## ADDENDUM NO. 1

**DATE:** April 2, 2019  
**FROM:** City of Grand Junction Purchasing Division  
**TO:** All Offerors  
**RE:** Riverside Park Improvements and Bike Path IFB-4621-19-DH

TENDON PLAN

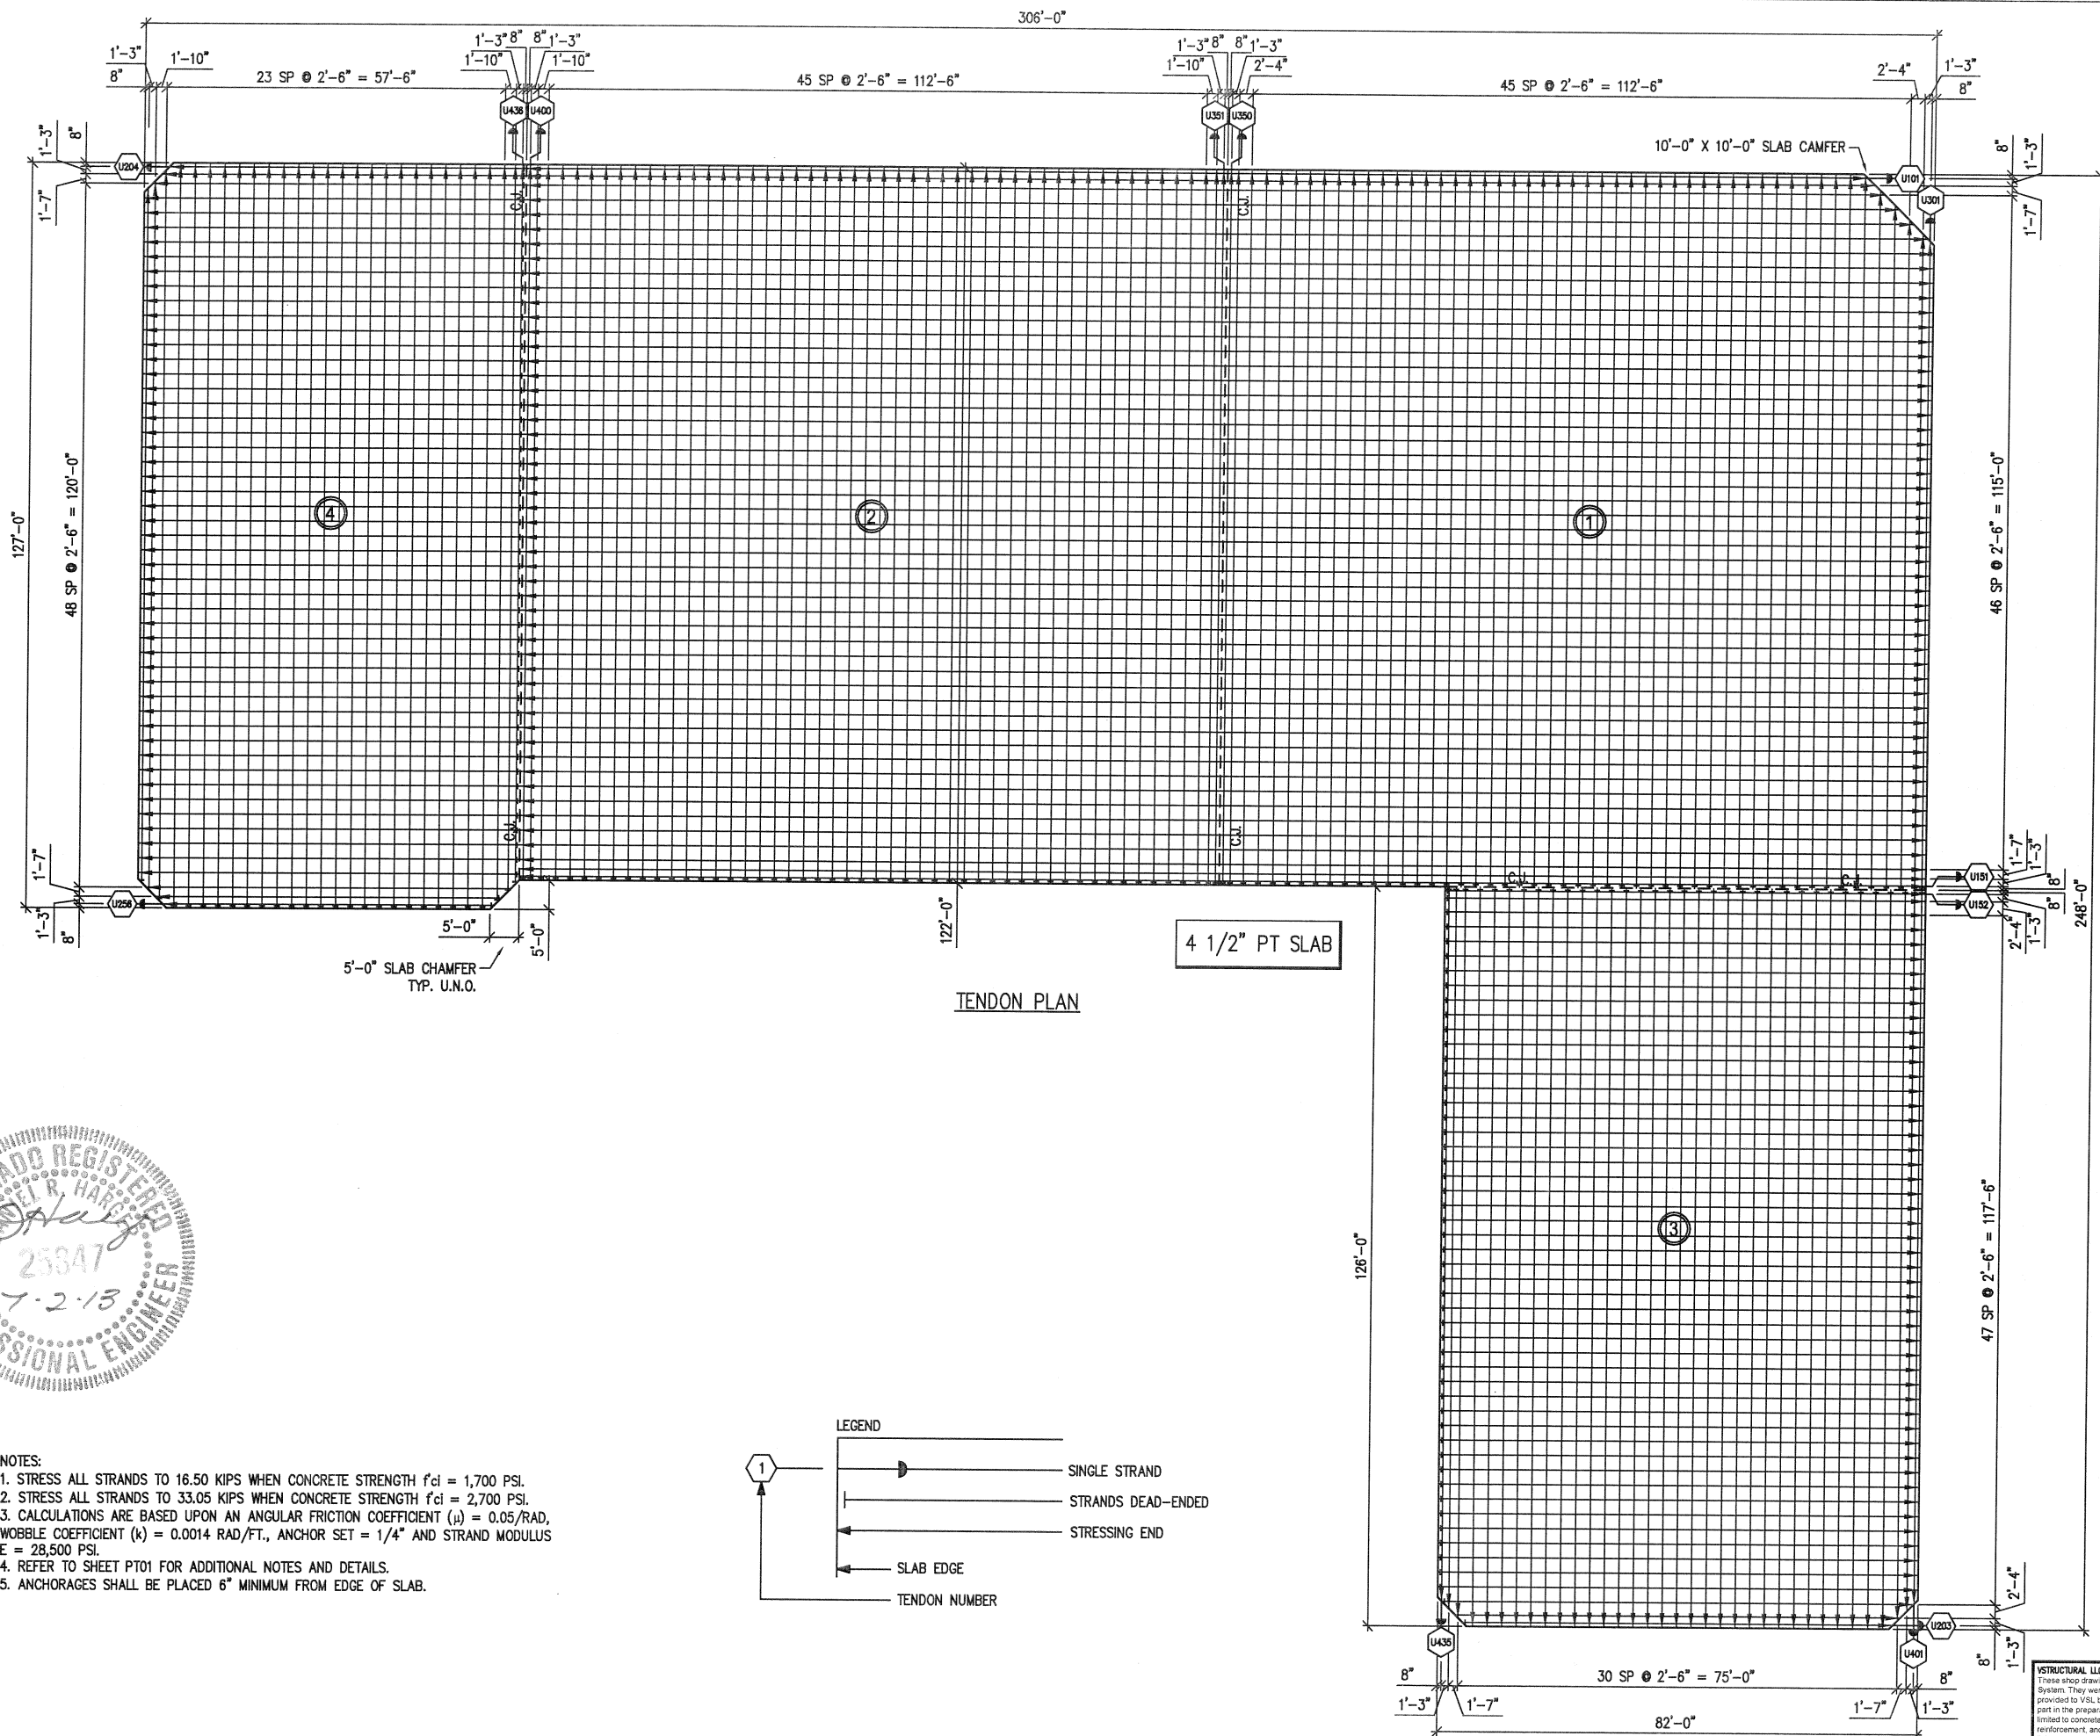
2. Q. Per the above mentioned project and pay item #33 "Post Tension Basketball Court" it states to include all appurtenances. Can you provide a list of appurtenances?

A. Yes. All appurtenances shall include, but not be limited to, all materials necessary to install the post-tension concrete slab. Stamped plans by a licensed Engineer are required. See attached post-tension tennis court slab plans as an example, which includes the tendon/reinforcement layout, slab section details and construction notes and specifications. 8" of class 6 aggregate base course installed under the slab shall be incidental to the slab cost, and will not be paid for separately. The appurtenances shall also include materials for the two (2) basketball hoop posts (to be installed within the extents of the post-tension slab), backboards, rims, and any other materials necessary to construct the basketball hoops. The City is only responsible for striping the court. Please note that the dimensions (45'Wx75'L) for the post-tension basketball court slab meet regulation size for Junior High School basketball courts.
